Piping Design Review

In early 1982, The Cleveland Electric Illuminating Company (CEI) conceptually defined the scope of a Design Verification Program. This was done to further our confidence in the Gilbert Associates, Inc. (GAI) design program and our recognition of the regulatory environment and its changing direction.

This report, Piping Design Review, represents one portion of that overall effort which includes design review programs addressing both Quality Assurance and Engineering objectives.

FIGURE 1

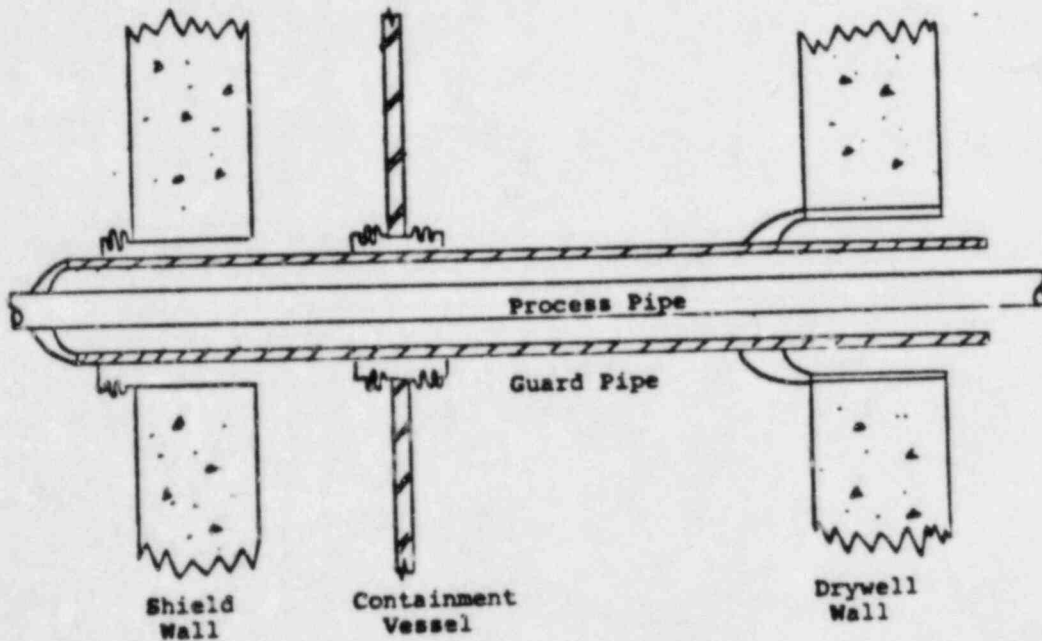
*The actual moment arm shown on the vendor drawing is 14.90 in.

e. The change in weight is summarized as follows:
